ELECTRICAL ADDENDUM #1

ELEC. ADDEN. No.: E1
PROJECT No.: 687
PROJECT NAME: Compass Early Learning Centre, Kirkfield, ON
DATE: March 21, 2025

re: Compass Early Learning & Care - Kirkfield Renovations
- Addendum Number Two

ADDENDUM NUMBER TWO
COMPASS EARLY LEARNING & CARE - KIRKFIELD RENOVATIONS
MARCH 25, 2025

PROJECT NO.: 2024-03	
DRAWN BY:	M.B.
CHK'D BY:	R.A.
SHEET TITLE	
Elevations	
DRAWING NO.	
A3-01

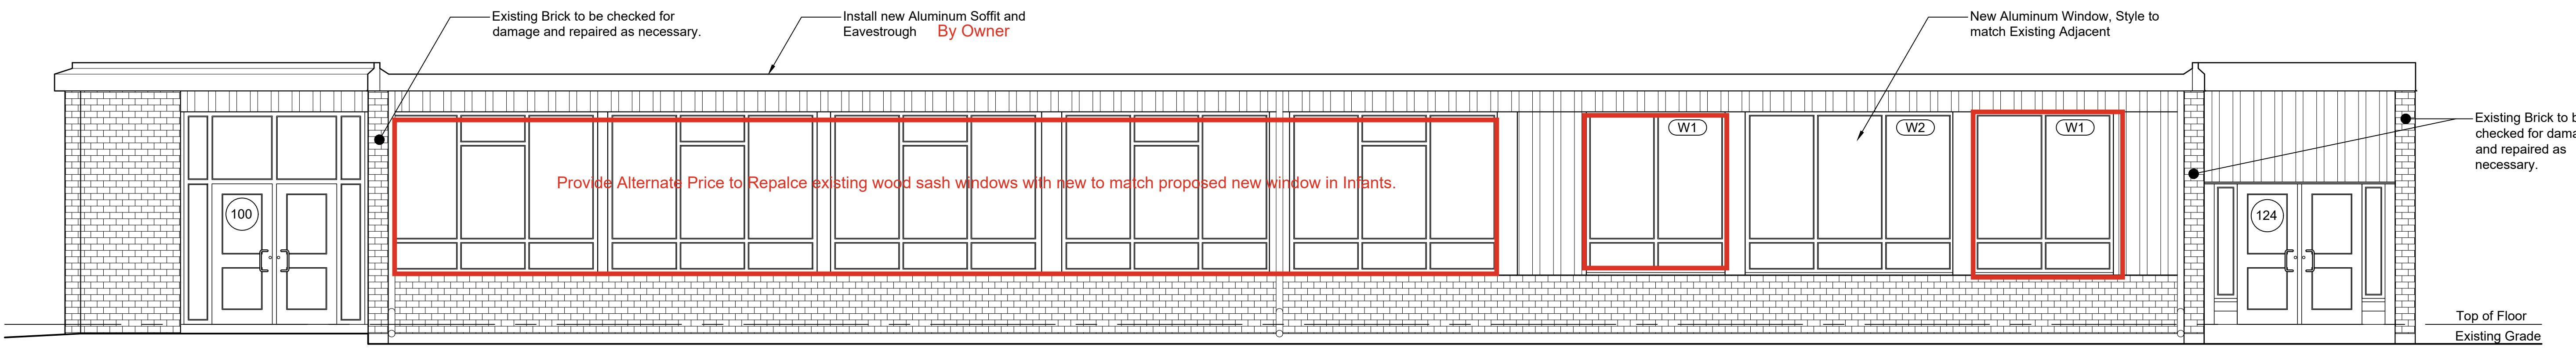
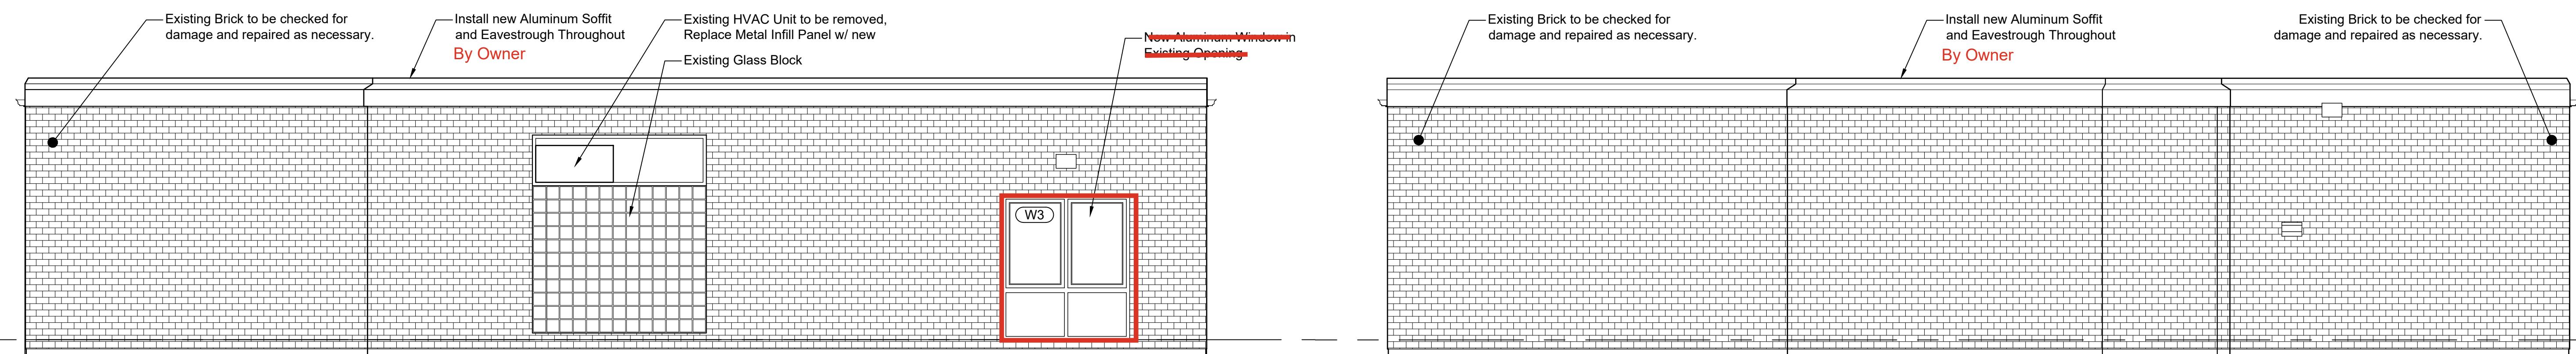
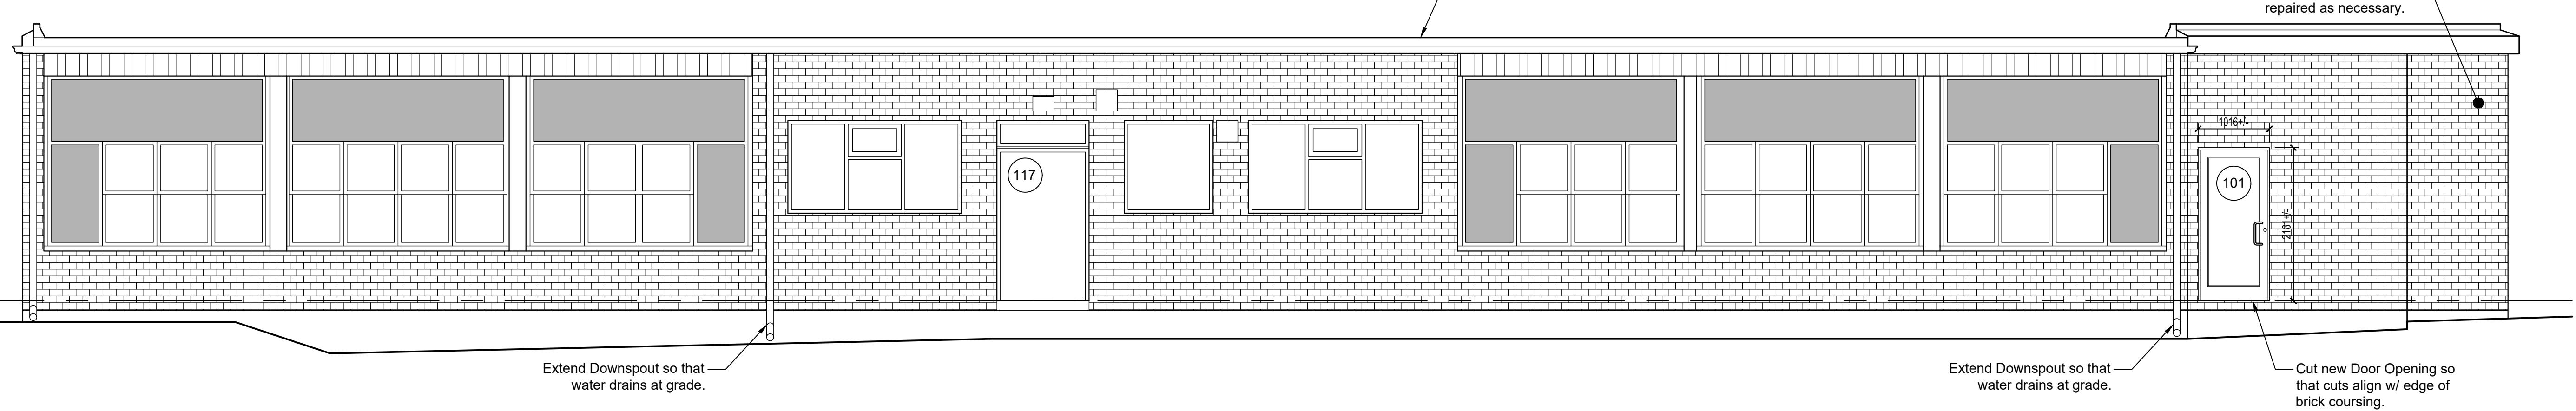
- 5.0** **Note:** Windows on south side to be included in Alternate Price are as indicated on A2-01 and A3-01.
- 6.0** **Note:** Wherever there are infills at existing doorways, these shall be gypsum board on steel stud, insulated. Where block adjacent to opening is to remain, finishing layer of gypsum board painted will overlap block with J mold trim 2" either side.
- 7.0** All glazing for doors and screens to be tempered 1/4" thickness unless otherwise noted.
- 8.0** Front sidewalk width as shown on Site Plan. Assume excavation down to 16"+/- and provision of granular base per OPSS 314 to 4" below finished grade compacted with OPSS 501.

A5.03

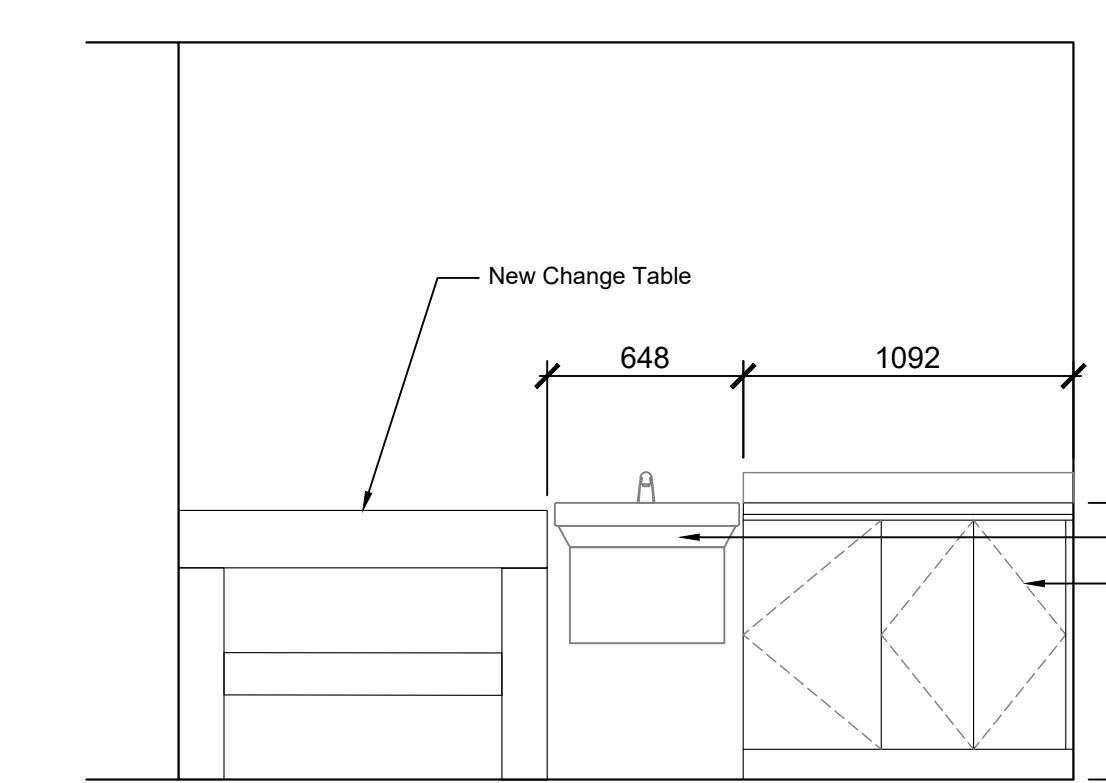
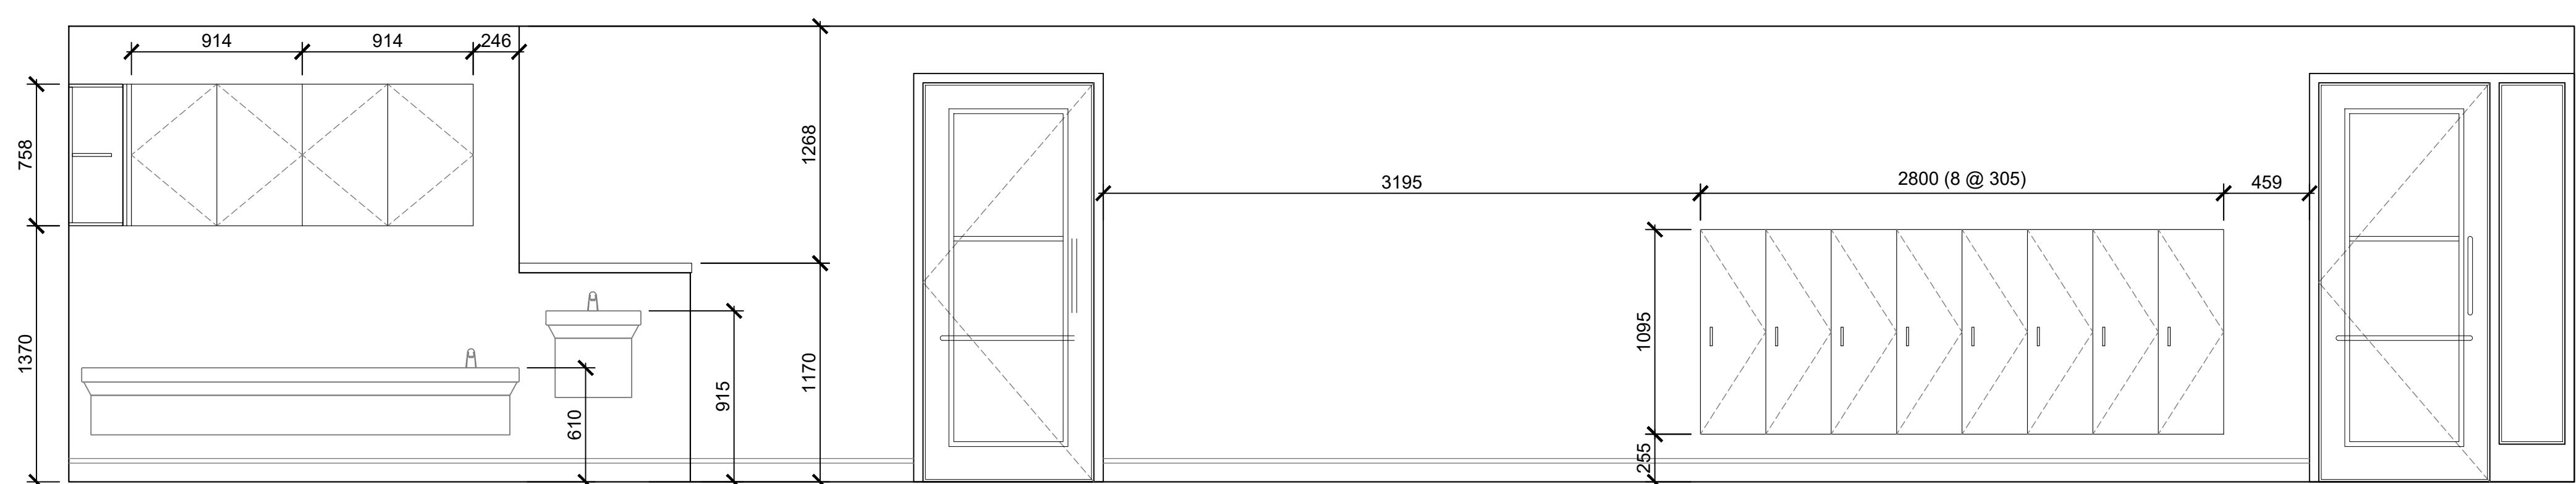
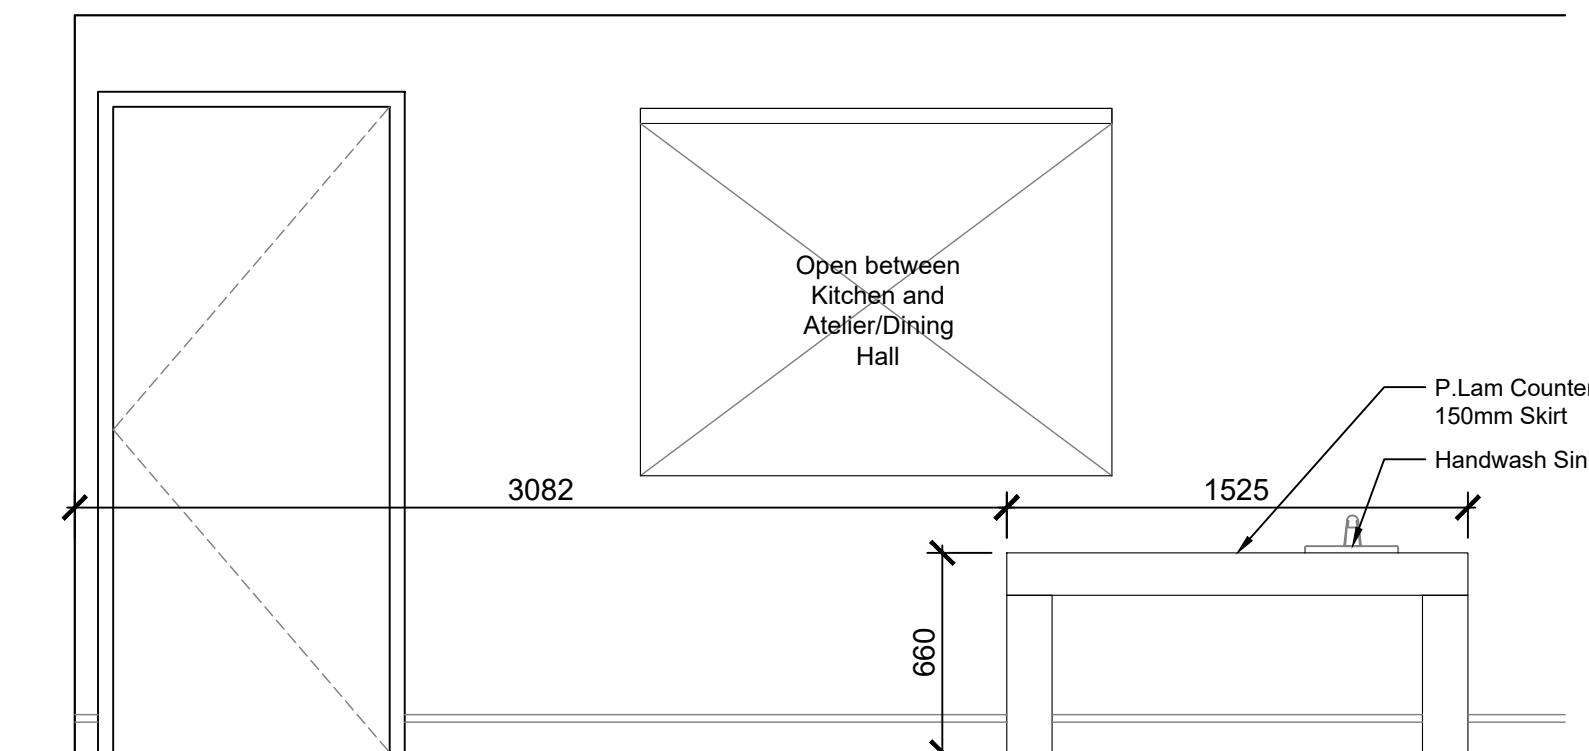
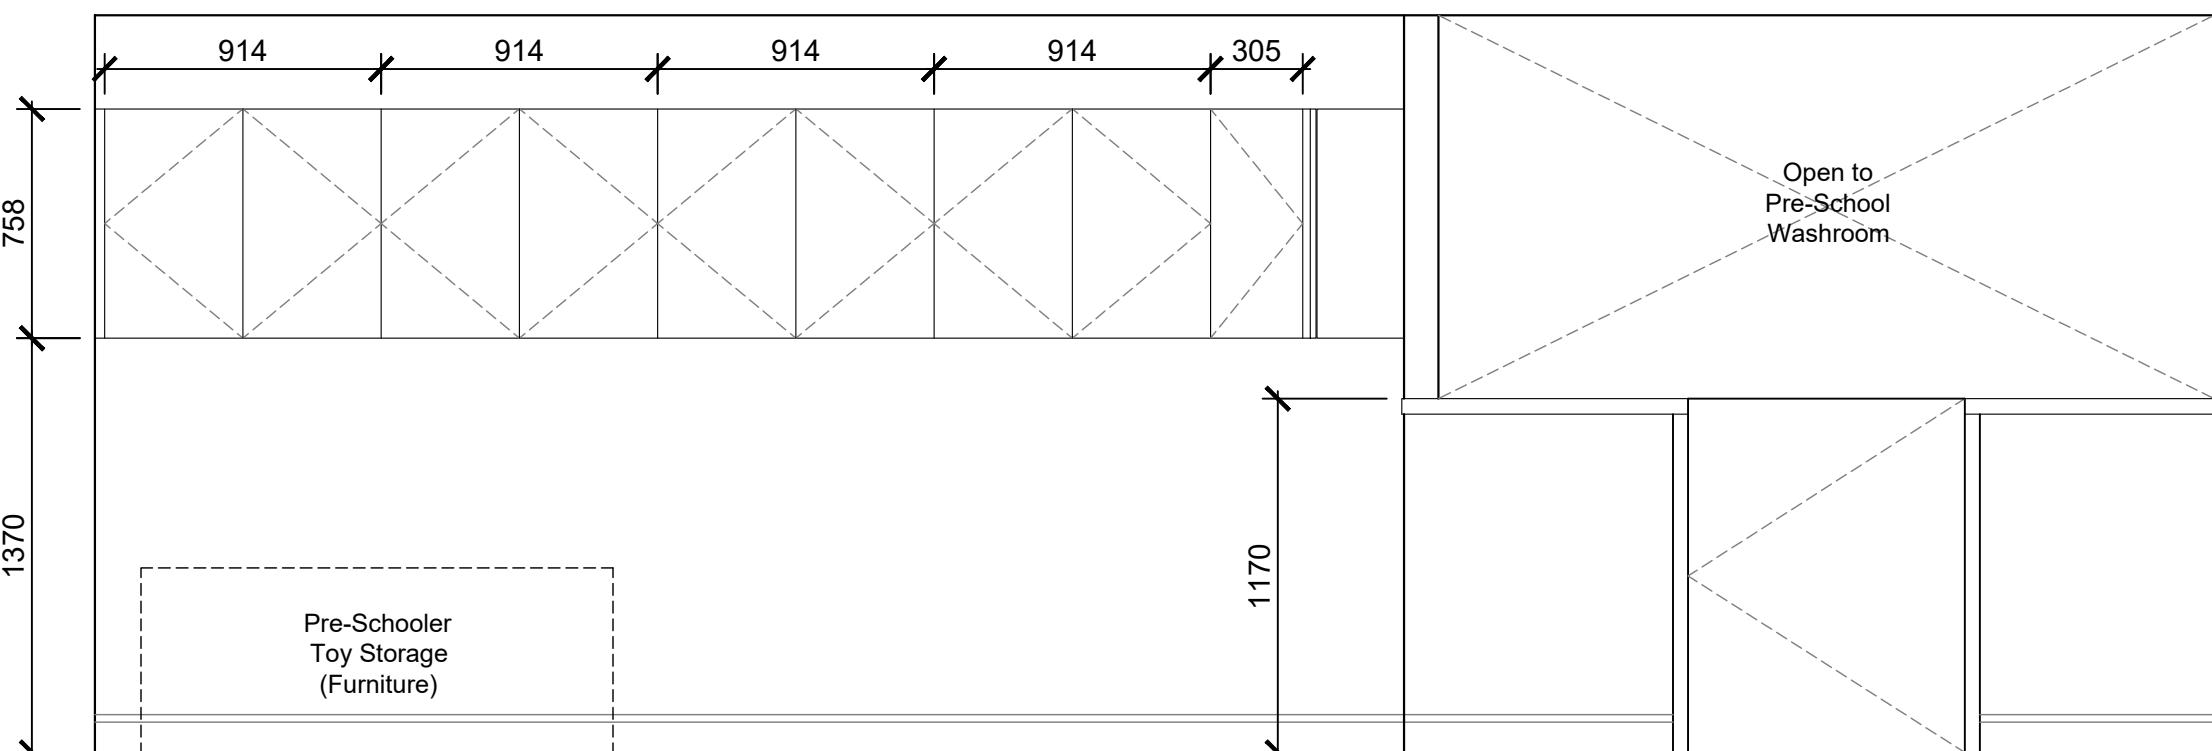
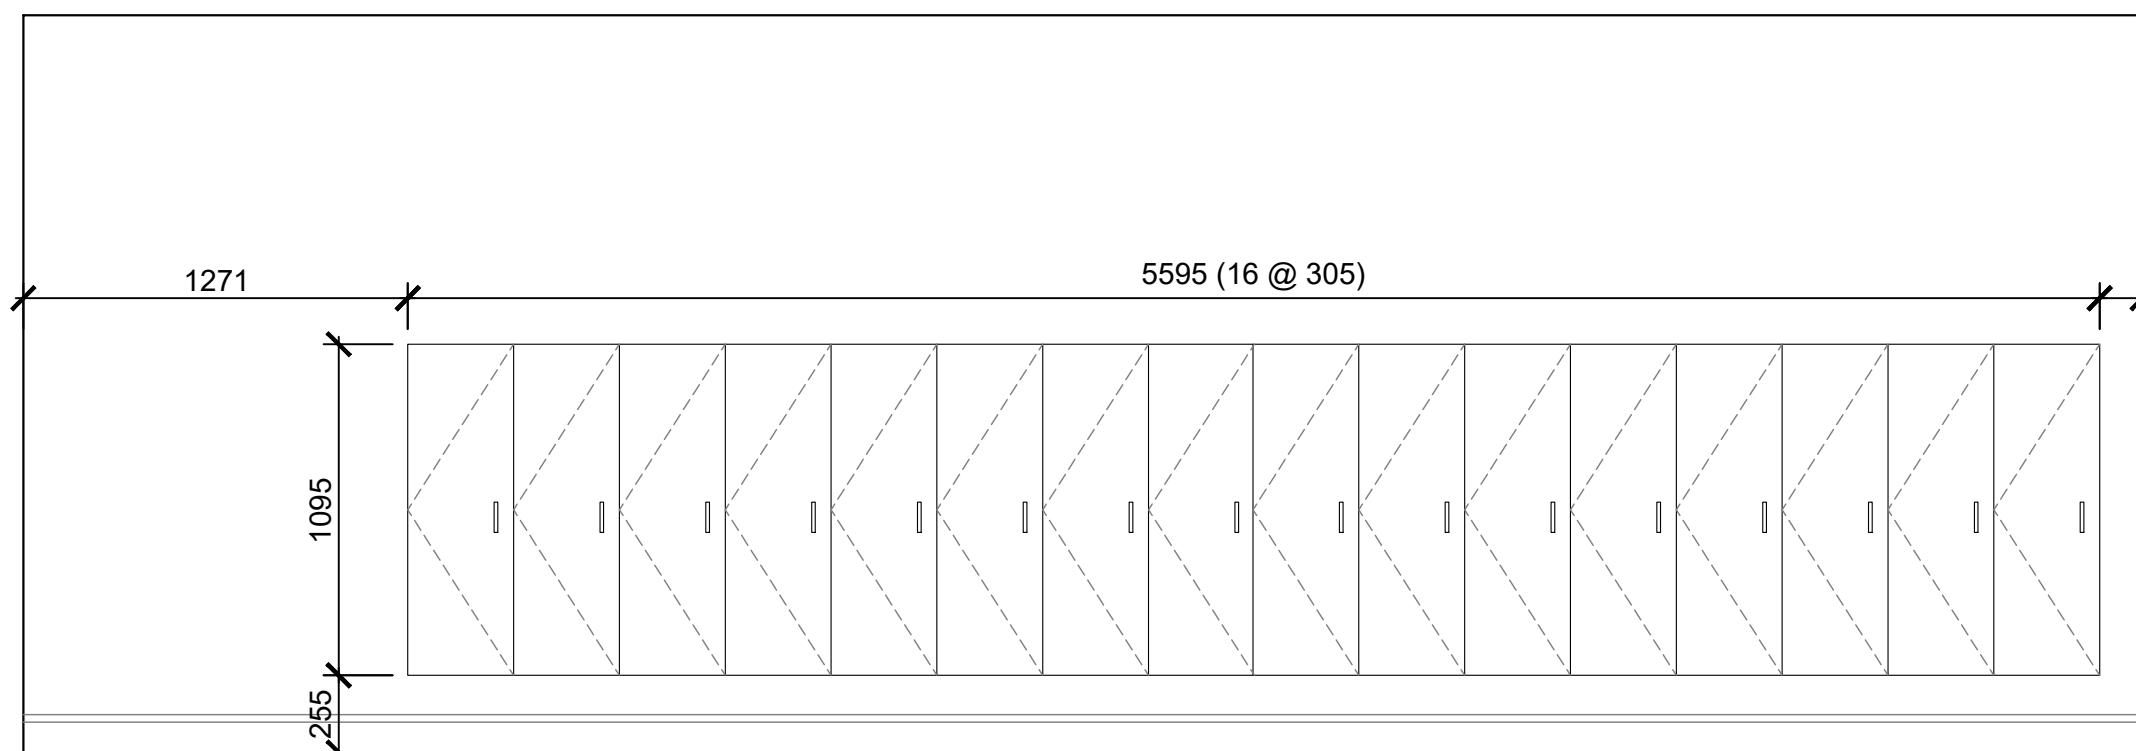
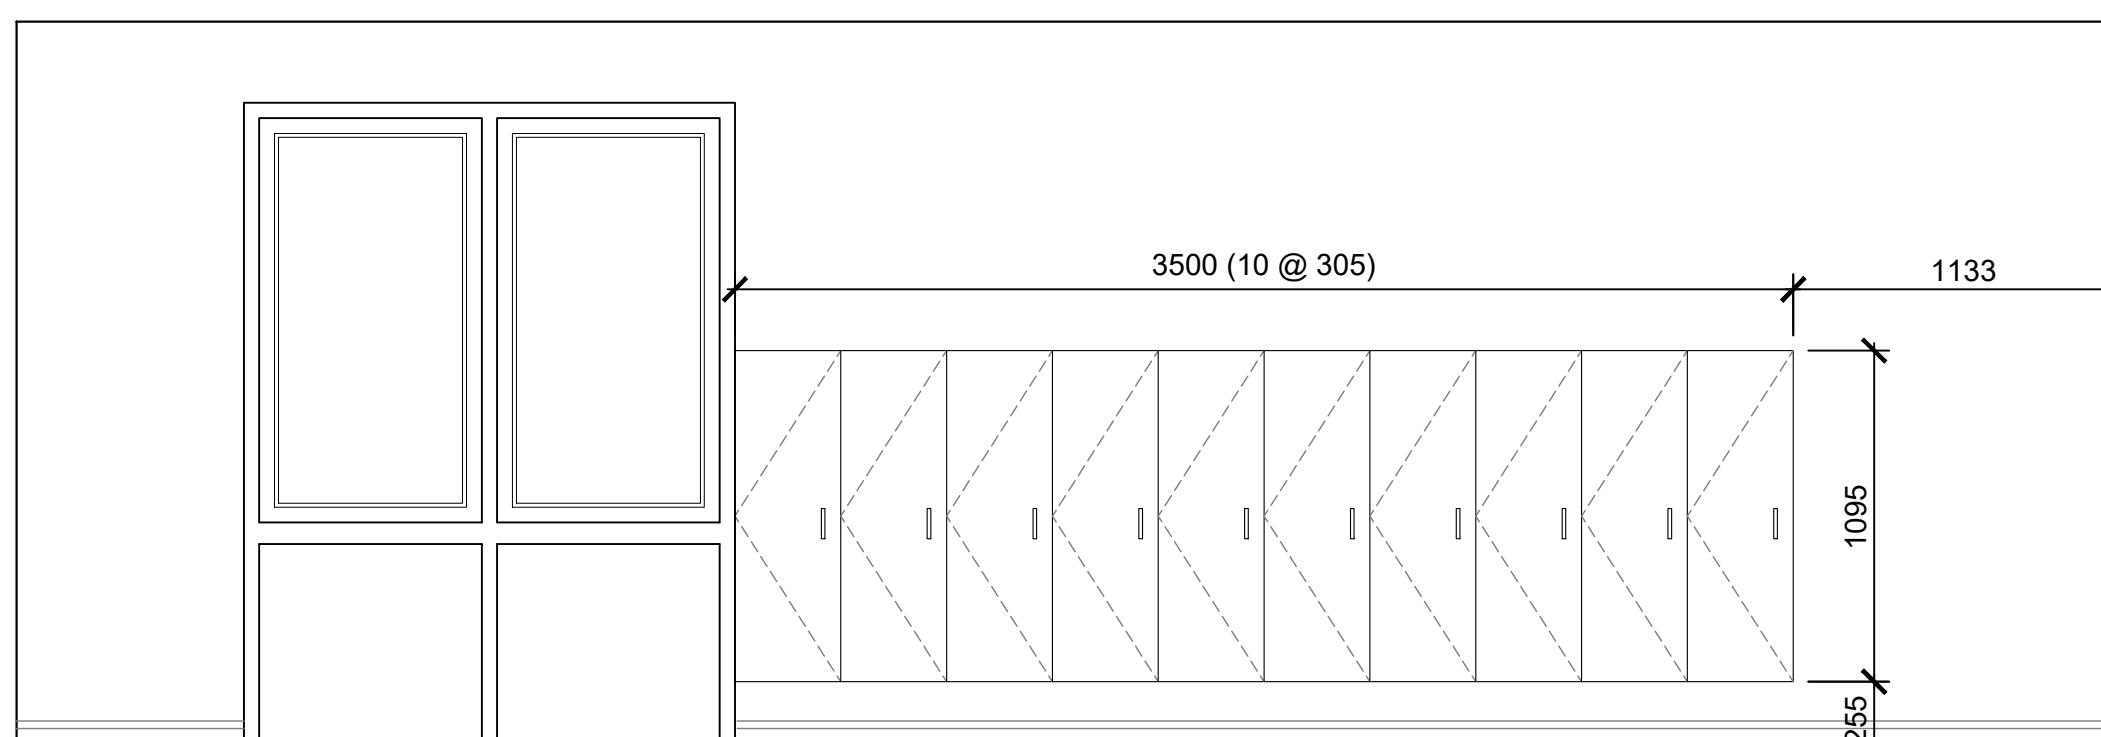
- 11.0** **Note:** All new millwork by this contract based on typical units for upper and lower cabinets per sheet and Elevation A5-03.
- 12.0** **Drawing S1-01: Note:** Provision of tactile indicators at top and base of sloped sidewalk and of handrail guard galvanized steel 1 1/2" diameter top rail 36" AFF, second rail at 24" AFF, bottom rail at 4" AFF.
